City of Miami Beach
Last Completed Item Reviews Across All Submittals

Permit Type: Building - Commercial **Work Class:** Alteration (w/o Phased) **Application Date:** 05/22/2020 **Status:** Approved
Address: 235 WASHINGTON AVE **Permit:** BC2013662

Re: Response to City Comments.

Sobe Hostel
235 Washington Ave.
Miami Beach, Florida

Sheet Number: E-1 1 OF 1

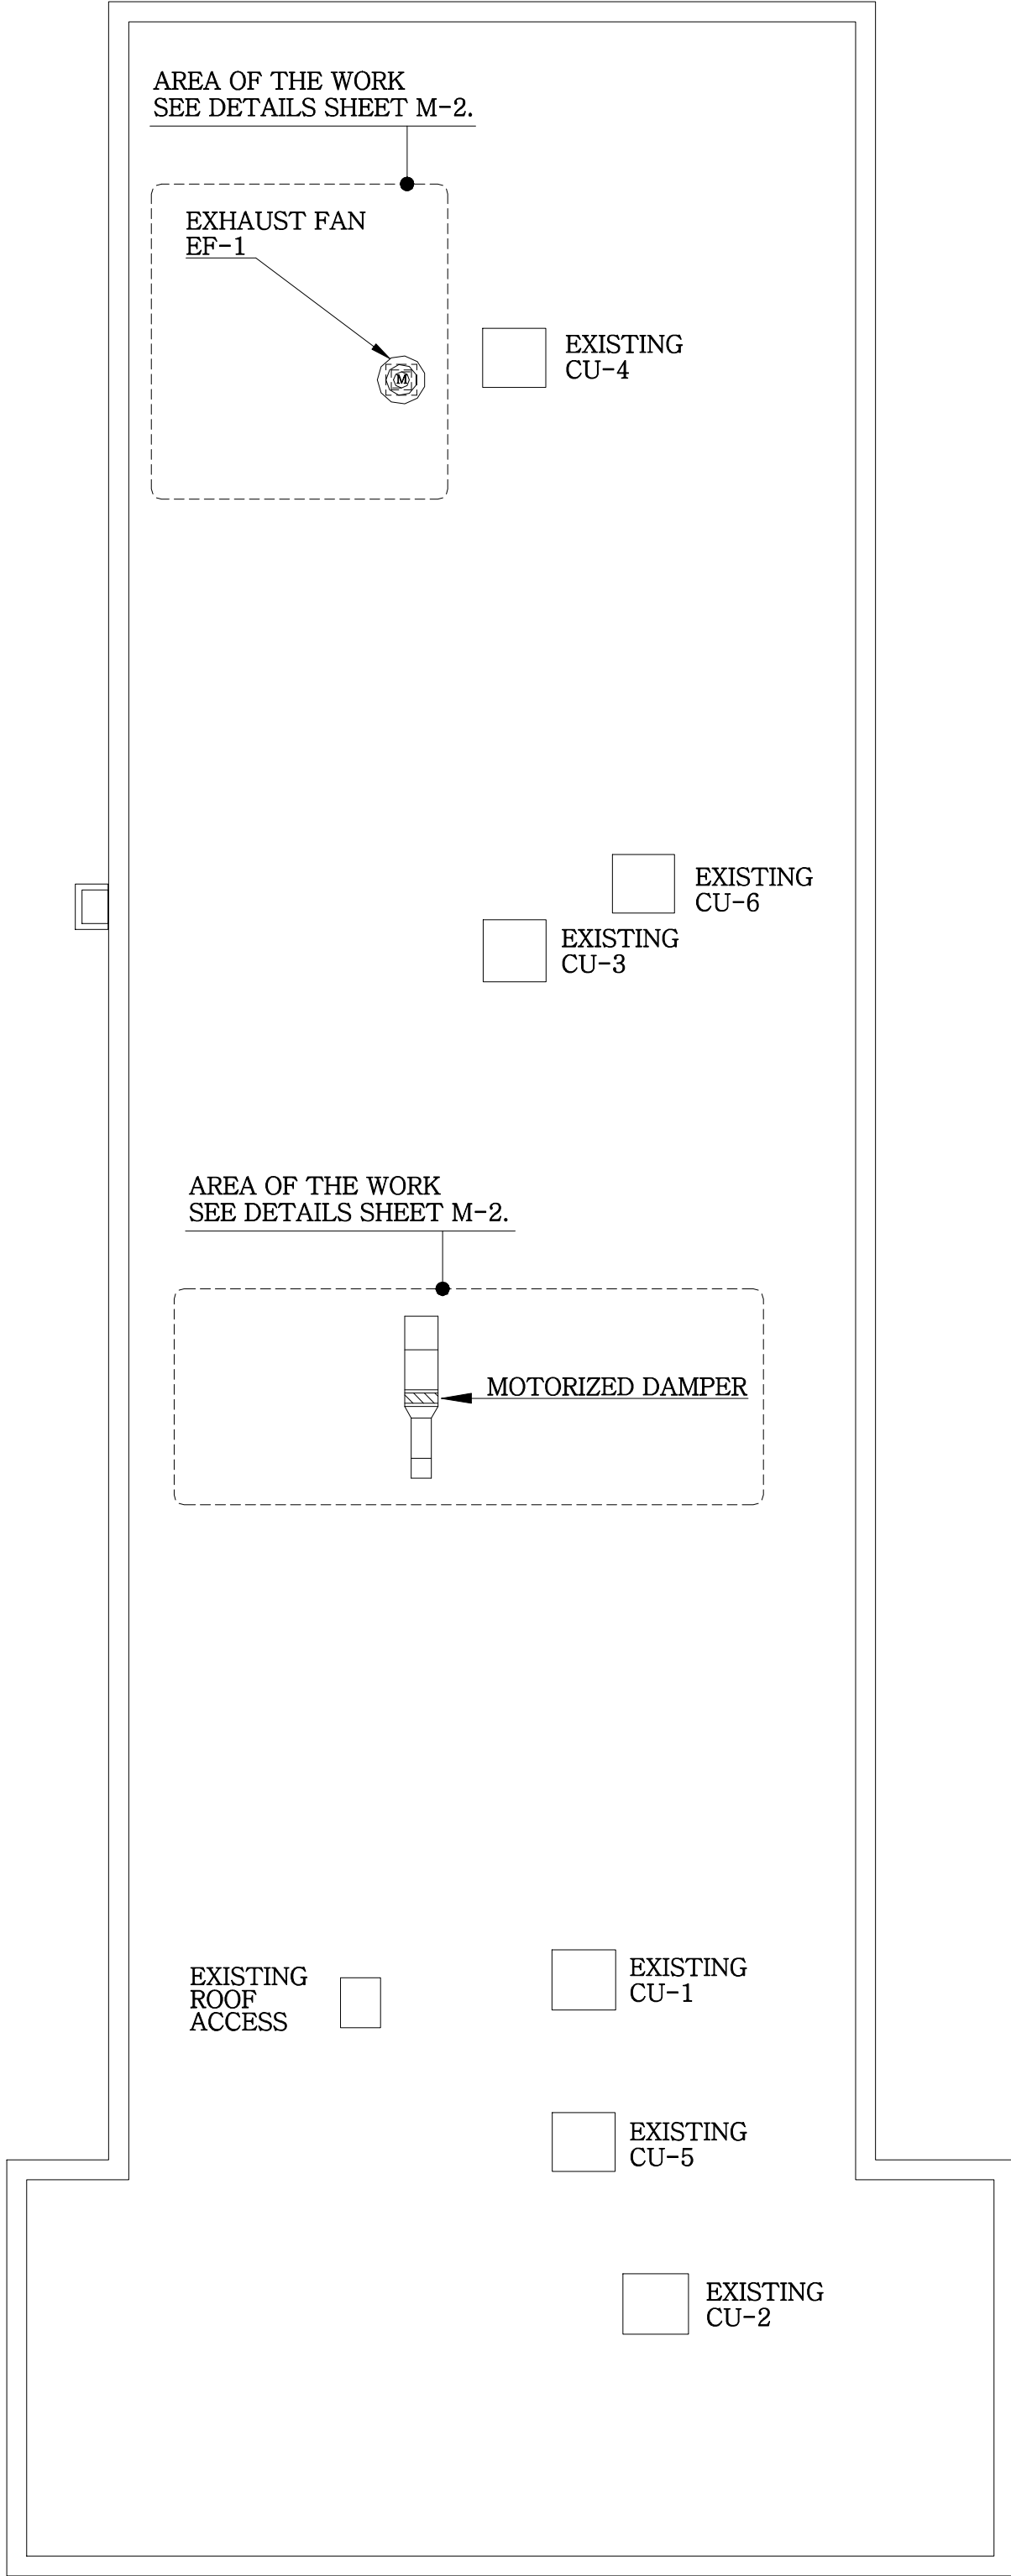
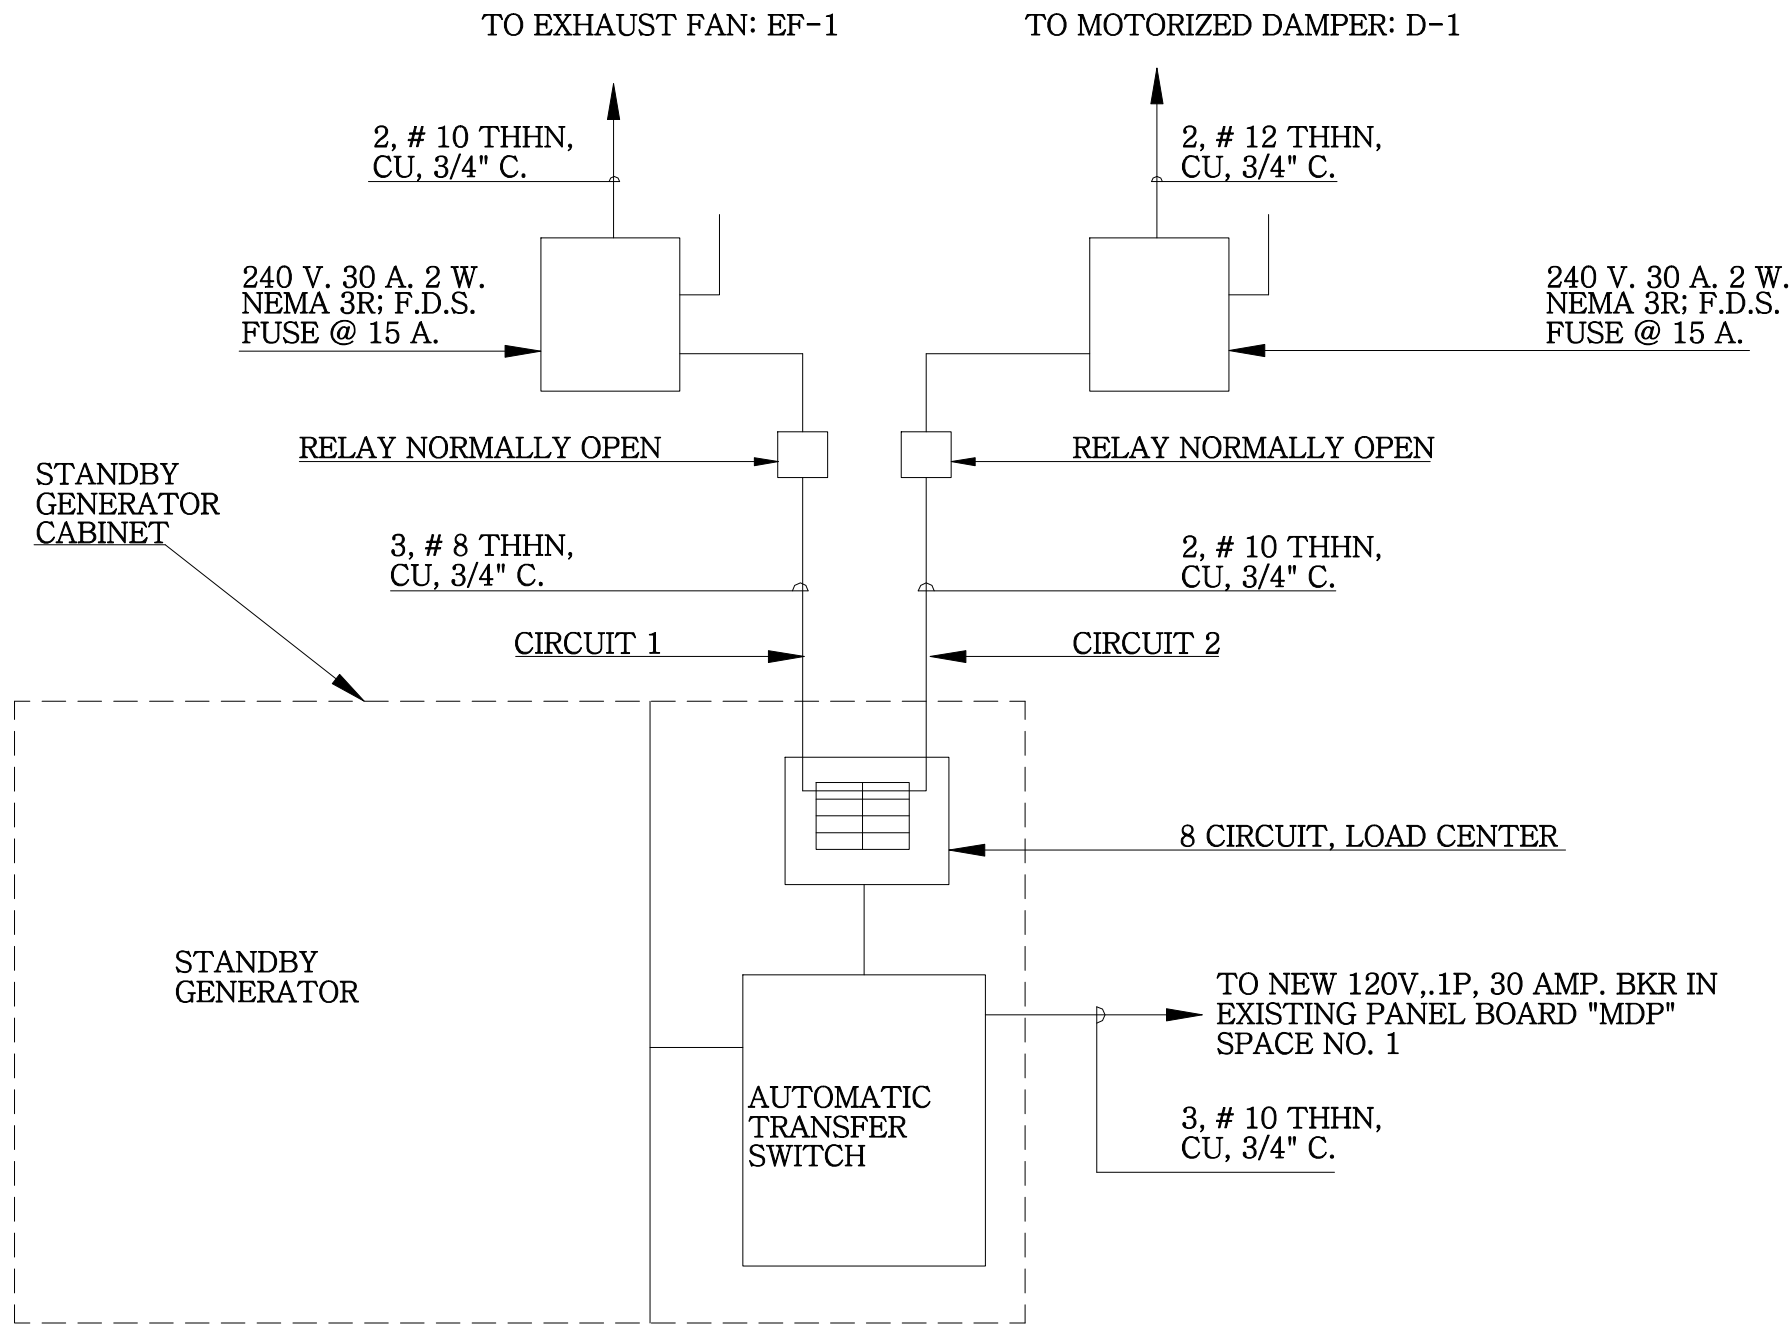
1. Plans state smoke control system but did not provide its sequence of operation to verify compliance with the ffpc 6th ed.

KKAID Response: Refer to Culpepper Specialty Engineer sheet E-1 for Smoke Exhaust System Sequence of Operation

4. This engineer has re-edited the sequence of operation of the smoke exhaust system notes and wiring diagram on Sheet E-1 in order to indicate to the Fire Control Contractor the sequences of operation desired. This engineer does not know the existing fire control system wiring diagram; that is, how are the existing smoke detectors, pull stations, etc. connected within the building's Fire Alarm Panel. This engineer has opted to use the existing supervisory devices in order to make the system less expensive. If new supervisory devices are required by the City of Miami Beach, so inform the owner and this engineer will include in these drawings new additional smoke detectors, new additional pull stations, etc. exclusive to this smoke exhaust system and with all the necessary specific control wiring diagrams required.
